Project	IEEE 802.16 Broadband Wireless Access Working Group < http://ieee802.org/16 >	
Title	Idle handover & location update in 802.16e	
Date	2004-03-05	
Submitted		
Source(s)	Changhoi Koo, Jungje Son, Seungil Yoon, Hyongoo Kang, Geunhwi Lim Samsung Electronic, Suwon P.O.Box 105, 416, Maetan-3dong, Yeongtong-gu, Suwon-si, Gyeonggi- do, Korea 442-742	Mailto : chkoo@samsung.com jungje.son@samsung.com siyoon72@samsung.com hyongoo.kang@samsung.com geunhwi.lim@samsung.com
Re:	Call for inputs for commentary of p802.16e/D1	
Abstract	This contribution describes handover in idle mode for IEEE P802.16e/D1-2004.	
Purpose	Discuss and Adopt enhanced feature of p802.16e/D1	
Notice	This document has been prepared to assist IEEE 802.16. It is offered as a basis for discussion and is not binding on the contributing individual(s) or organization(s). The material in this document is subject to change in form and content after further study. The contributor(s) reserve(s) the right to add, amend or withdraw material contained herein.

Idle hand over & Location Update in 802.16e.

Figure XX. Idle Handover Procedure

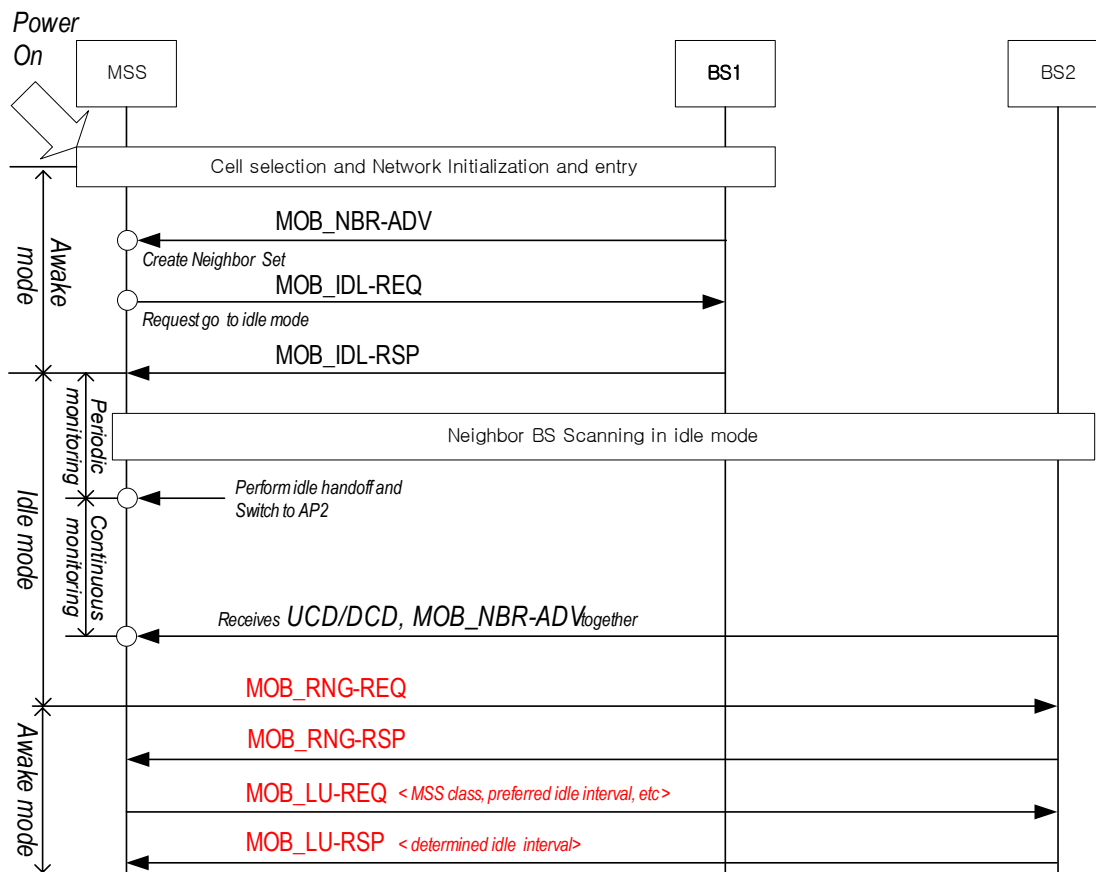
6.4.18.4 Idle handover in idle mode

An idle handover occurs when an MSS in idle mode moves from the coverage area of the current serving BS to the coverage area of another BS. The MSS in idle mode shall periodically search for the strongest cell on the corresponding frequency. And while in idle mode, the MSS shall update the neighbor set whenever it detects that the **MOB_NBR-ADV** message is changed. If the MSS determine that one BS of the neighbor set is sufficiently stronger than a serving BS, the MSS shall perform the idle handover procedure. If the MSS performs the handover in idle mode, it is called the idle handover.

While performing the idle handover, the MSS shall monitor all frames temporarily in order to receive **UCD, DCD,** and **MOB_NBR-ADV** messages on the broadcast CID transmitted by the neighbor BS. After receiving all these messages, the MSS shall resume the periodic monitoring operation.

During the idle handover procedure, the MSS shall receive **MOB_NBR-ADV** messages of a new serving BS and then the MSS shall update handover related parameters.

After performing the idle handover, the MSS shall discard all unnecessary messages received in the broadcast CID of the old serving BS. The MSS shall start Normal Operation of idle mode with a new serving BS and, if needed, it perform the Location Registration using **MOB_LU-REQ/RSP** messages.

The Figure shows the overview of performing the idle handover from BS1 to BS2.

Figure XX. Timer Based Location Update Procedure

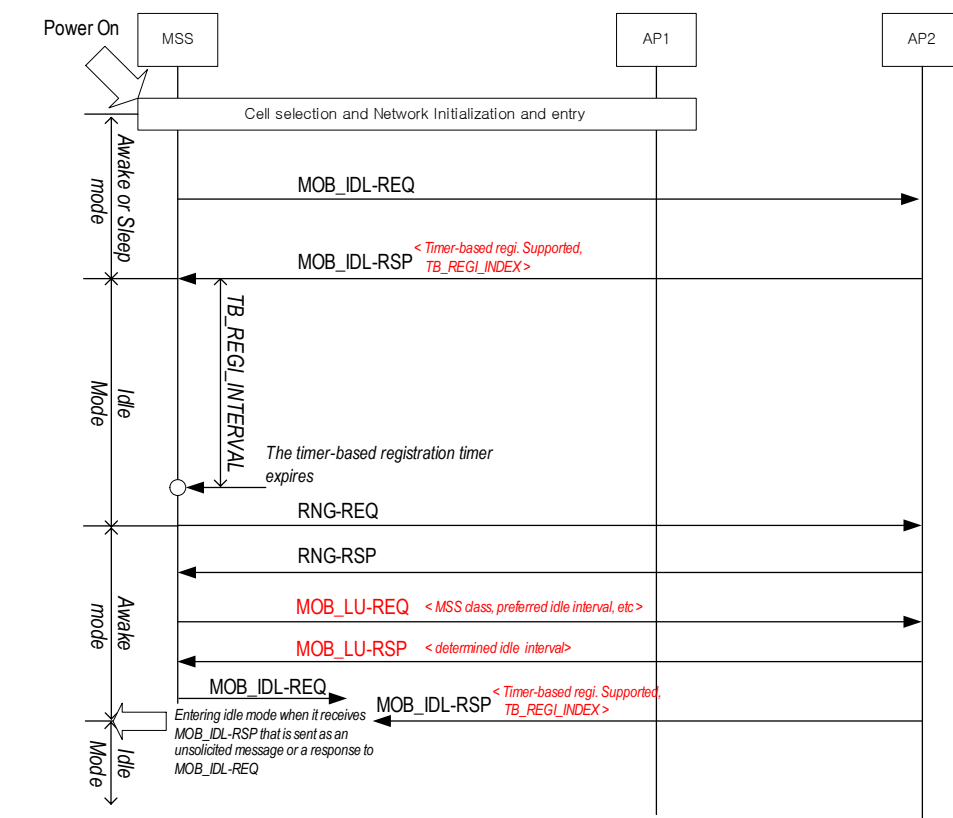
6.4.18.4.1.2 Timer-based registration

Upon entering idle mode, the BS can enable or disable the MSS to register the location when a sp-ecified timer expires. The BS shall inform the MSS of timer-based registration capability using the TB_REGI_REQUIRED field of the MOB_IDL-RSP message. A value of the timer is set to the TB_REGI_INDEX field of the MOB_IDL-RSP message. The MSS shall restart this timer when re-ent-ering idle mode if the timer-based registration is enabled.

The timer-based registration causes the MSS to register at regular intervals, TB_REGI_INTERVAL. If the MSS detects that it has to perform the zone-based registration and the timer-based registration simultaneously, the MSS shall perform the zone-based registration and ignore the timer-based registration.

The MSS shall compute the timer expiration count as

$$TB_REGI_INTEVAL = 2^i \times T$$

, where i is REST_INTERVAL_INDEX and T is the TB_REGI_INDEX.

The TB_REGI_INTERVAL is an integral multiple of the REST_INTERVAL and so the MSS can increment the timer-based registration counter every specified multiple of REST_INTERVAL frames. The counter is reset when the timer is restarted.
